City of Columbia

Municipal Planning Commission

April 14, 2021

RE: Tri Green
Final Master Development Plan
Responses to Staff Review Comments

TRI GREEN EQUIPMENT
271 THETA PIKE
COLUMBIA, MAURY COUNTY, TENNESSEE
FINAL MASTER DEVELOPMENT PLAN

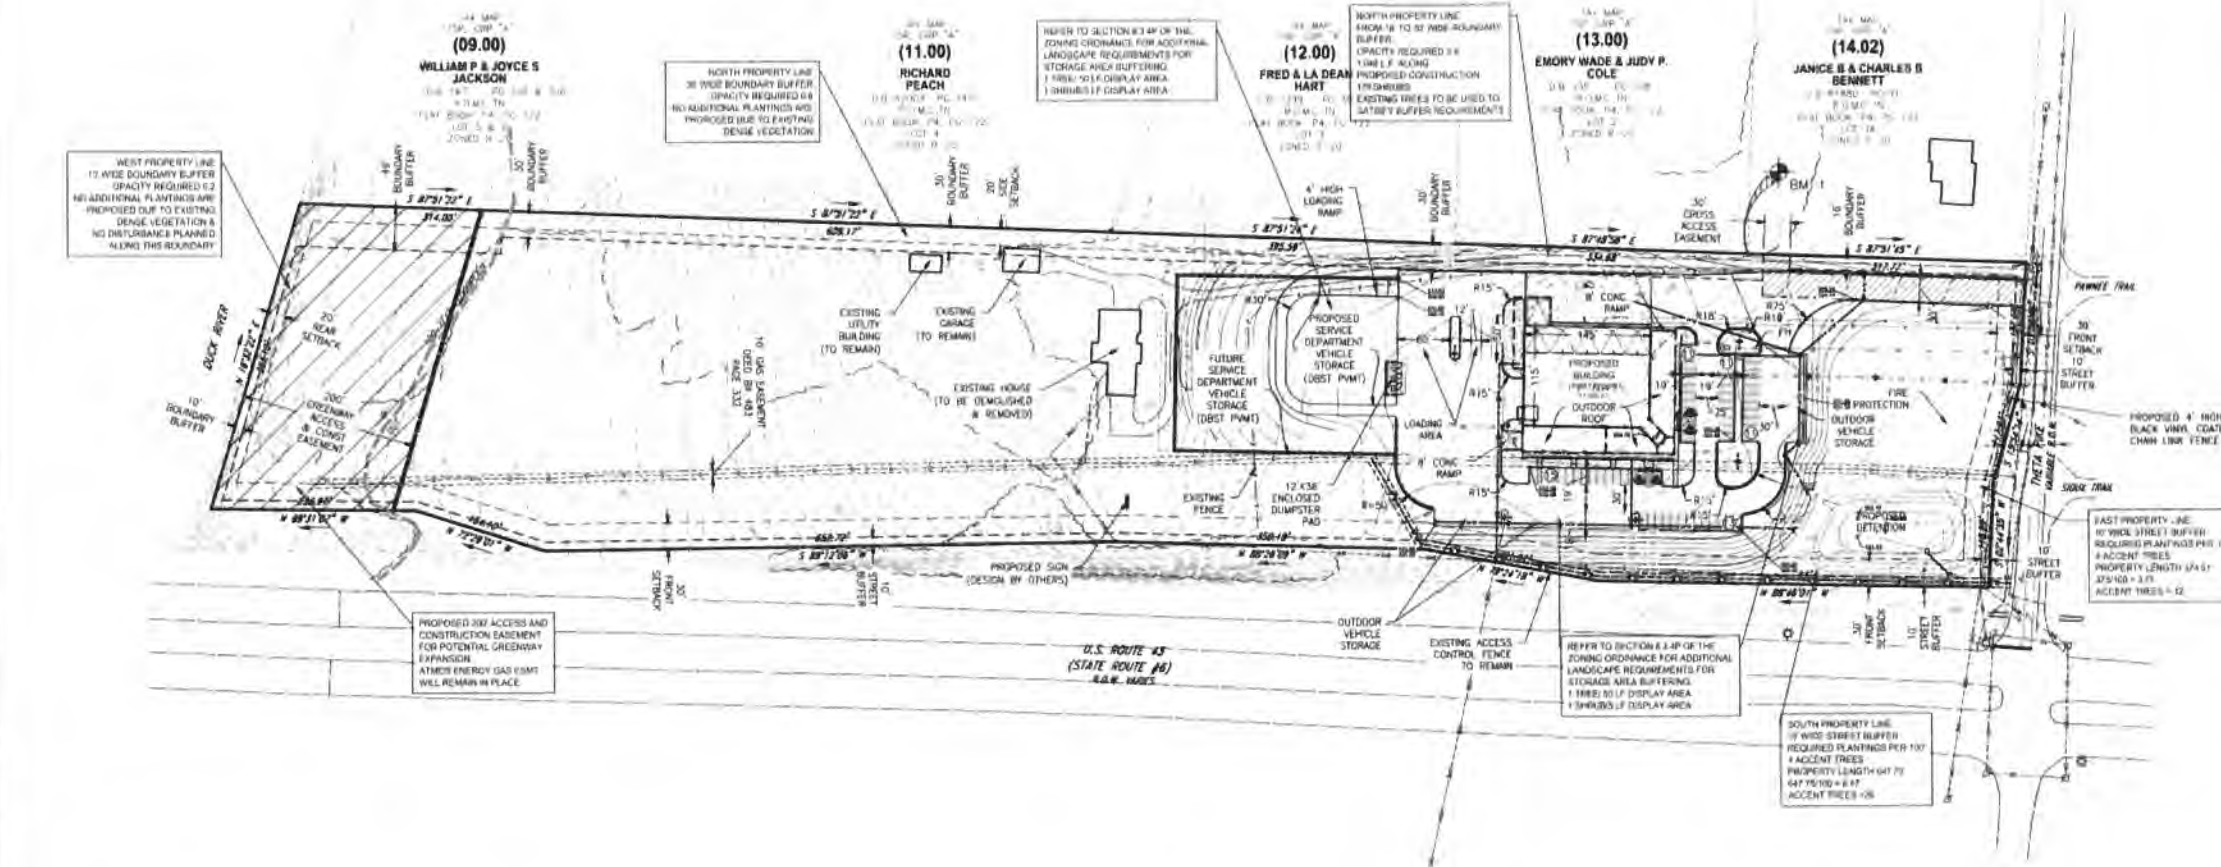
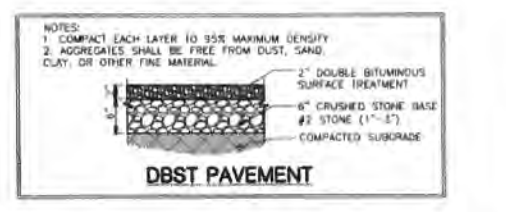
1. Analysis of downstream storm structures will be required for construction plans
2. Subject to construction plans.

3. Building Construction plans must include: 2 hr wall detail, Brace wall plan detail.

5. The Wastewater Department has a 10" gravity service line running along Theta Pike with capacity to service the proposed building. The department would like to be contacted to determine the size and scope of the oil and grit separator required to service the facility.
The existing 10" gravity main is shown on the plans. I will coordinate with the Columbia WWTP on the oil / grit separator.

6. 6" CI main on East side of Theta Pike. Meter that goes to 271 Theta Pike in center of property.
Location noted on the plans.

1. Analysis of downstream storm structures will be required for construction plans
Analysis of downstream storm structure will be added to the calculations.
2. Subject to construction plans.
Construction plans have been submitted to Engineering for review.

3. Building Construction plans must include: 2 hr wall detail, Brace wall plan detail.
Building Construction plans should include 2-hr wall detail and brace wall detail (per Architect).

4. Please see attached dumpster guidelines.
Dumpster guidelines have been reviewed and the trash corral dimensions have been noted on the plan.

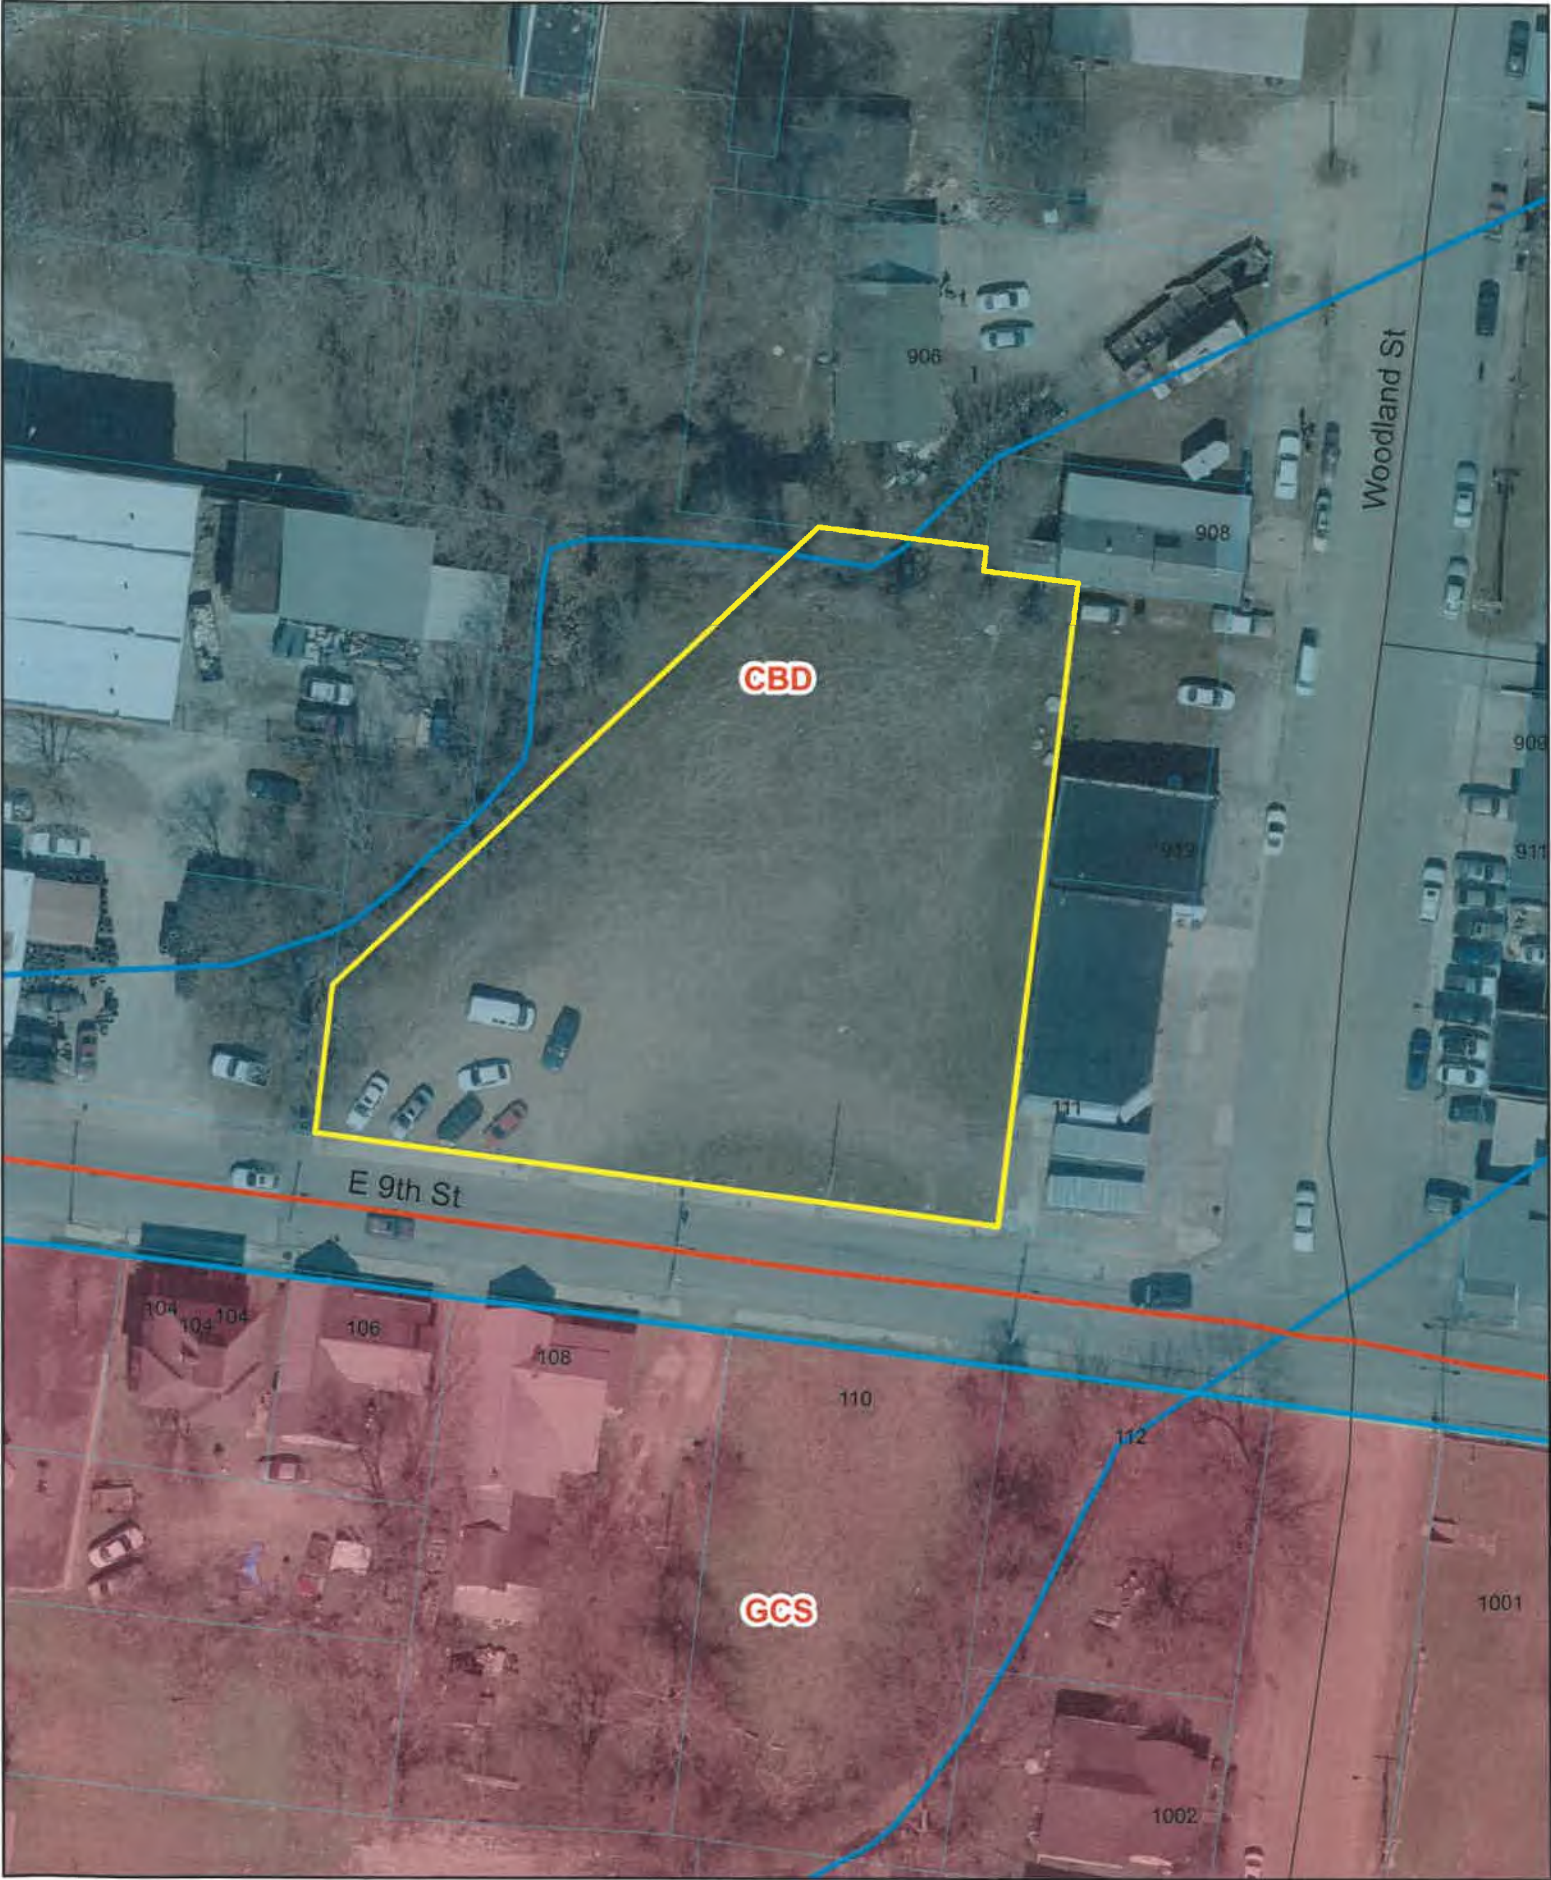
10. Wastewater has a 12" gravity line running along E. 9th Street that should provide available capacity to service the proposed units.

11. Subject to construction plans
12. List minimum FFEs per previous approved site development plan. (595.5 C, 594.5 D, 594 for A & B)
13. All street cuts and utility cuts shall meet utility and street cut ordinance.
